RE: Docket No. 466: Frost Bridge to Campville 115-kV Project
Development & Management Plan Change Notice Request:
Proposed Improvements to Existing Access Roads to Structures 16 and 17
Town of Watertown

Frost Bridge to Campville 115-kV Project Development & Management Plan

Watertown, CT | Map Sheet 06 of 35

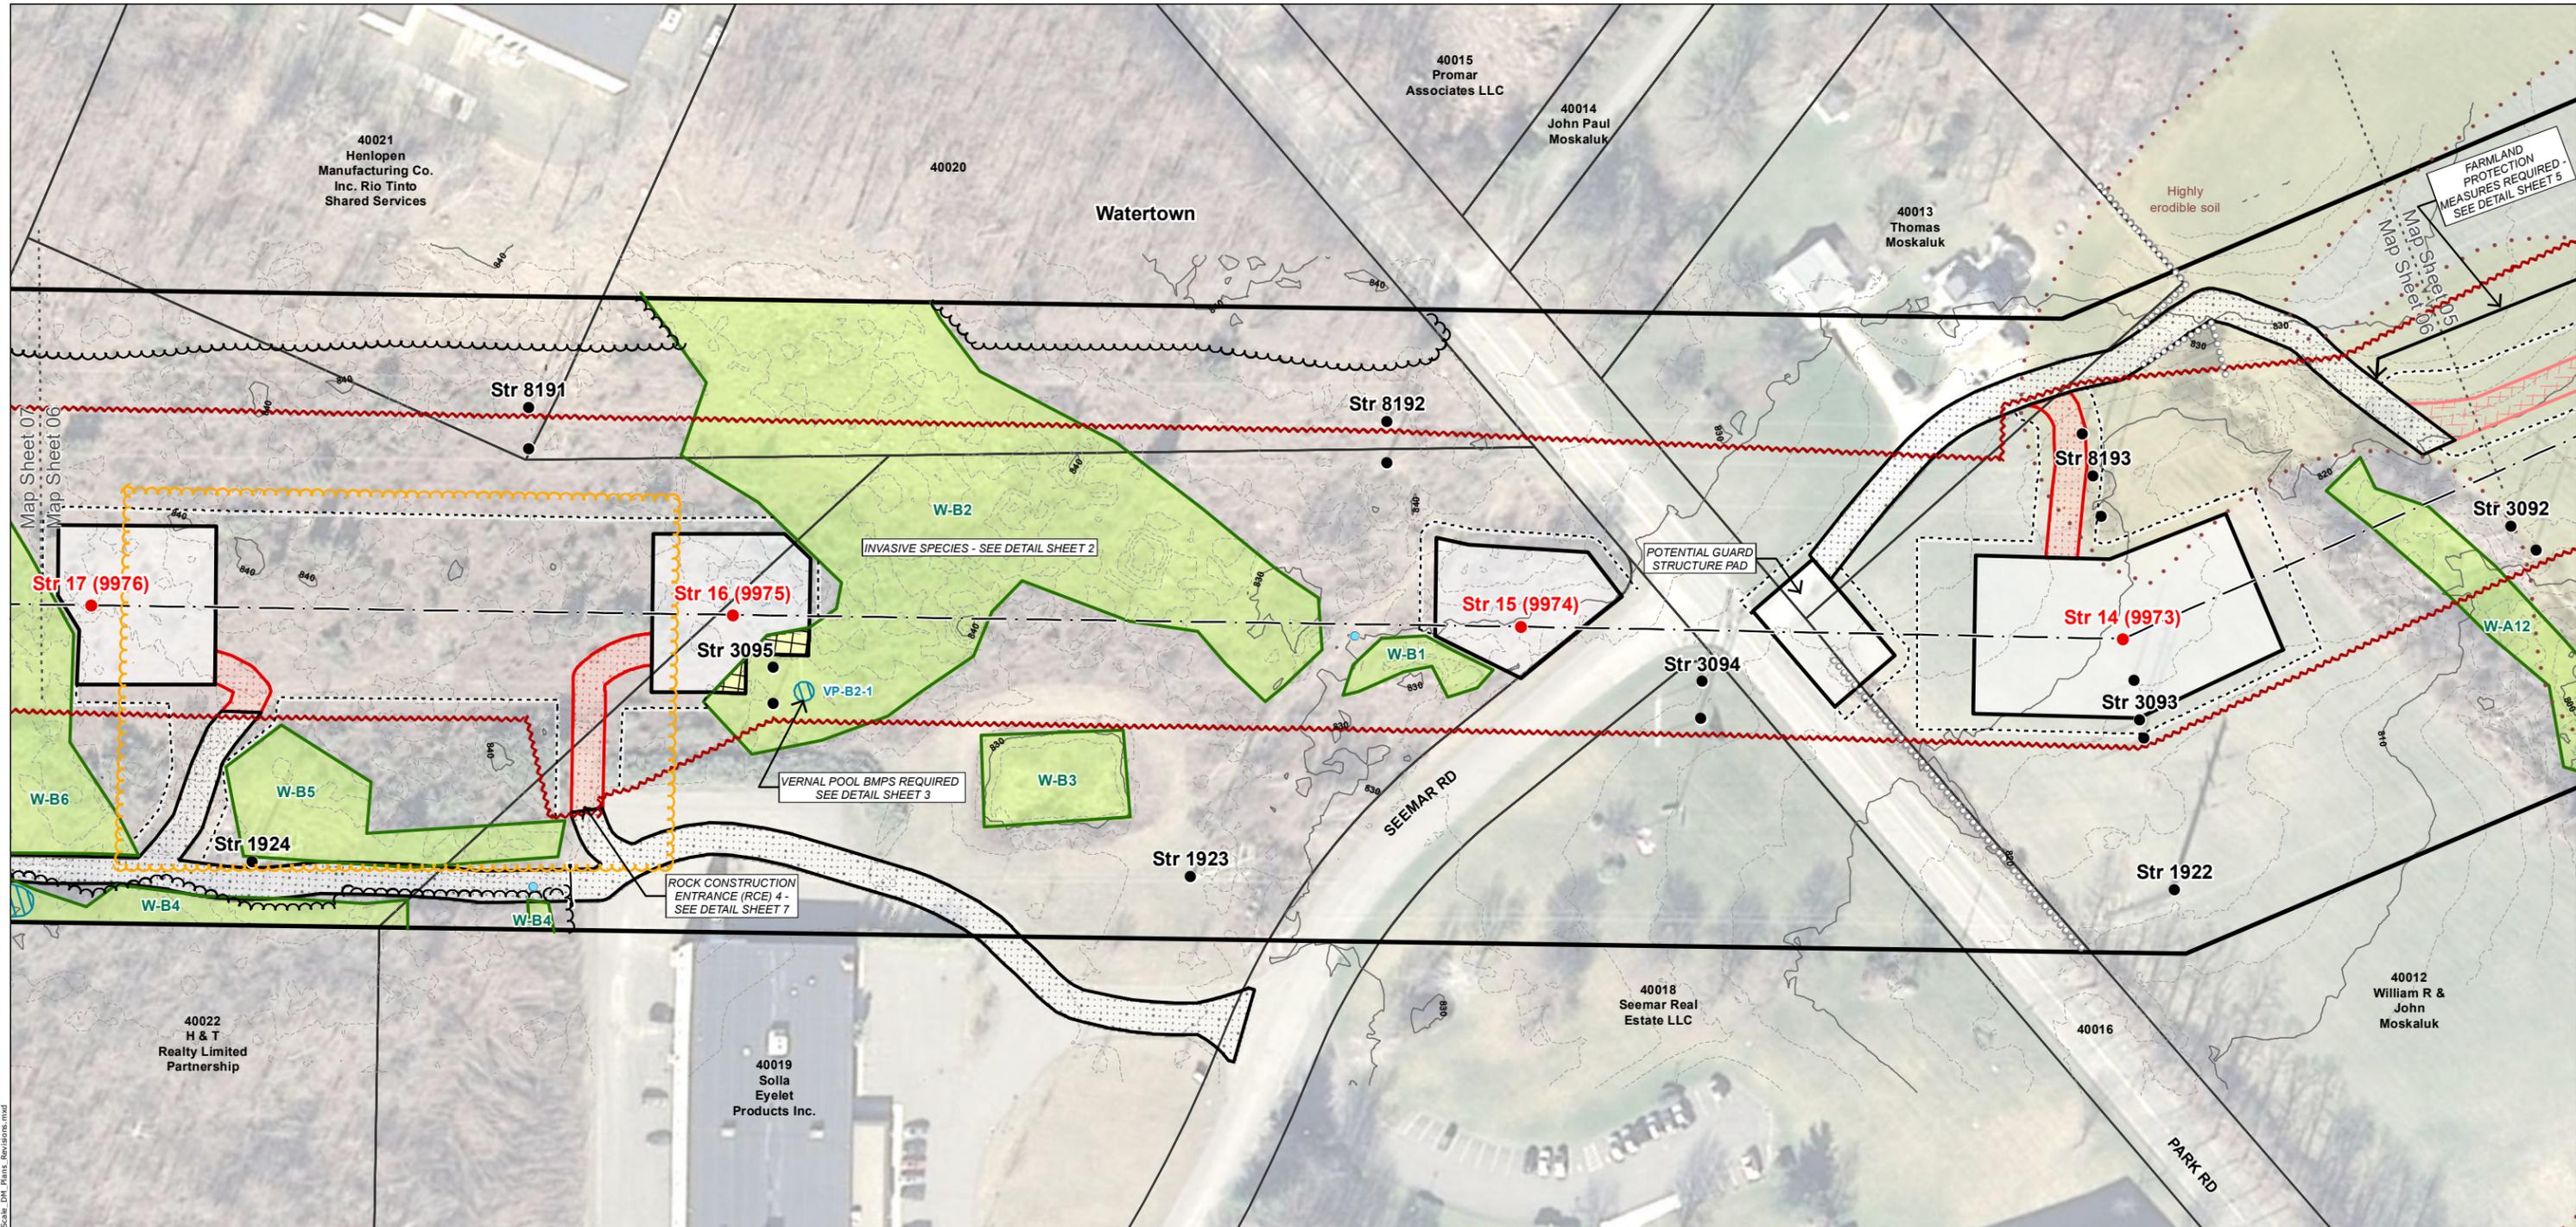
Eversource has determined that the approved 275-foot-long pull pad between new Structures 16 and 17 is no longer required for wire installation activities; consequently, this pull pad will not be installed. Since this pull pad was also intended to provide ingress/egress to Structures 16 and 17, spur access roads are required to reach the structure work pads. The previously approved access road spur to Structure 16 will be extended to the northeast through the previously approved pull pad area to reach Structure 16. The proposed spur access road to Structure 17 will be comprised primarily of an existing access road with a minor portion of new road being developed in the previously approved pull pad area to reach Structure 17. The existing access spurs will require hardening, but any improvement to the proposed revised access to Structures 16 and 17 will result in less ground disturbance than that associated with the approved pull pad. Both spur access roads are entirely within Eversource's existing 400-foot-wide right-of-way. The attached revised D&M Plan Volume 3 map sheet 06 shows these revisions. Eversource has informed the landowner of the planned access road location, improvements, and use.

NO.	DATE	REVISIONS	BY	CHK	APP	APP
REV 1	5/9/2017	EXISTING ACCESS ROAD TO BE IMPROVED/ USED FOR CONSTRUCTION; PULL PAD BETWEEN STRUCTURES 16 AND 17 WILL NOT BE BUILT		NC	MD
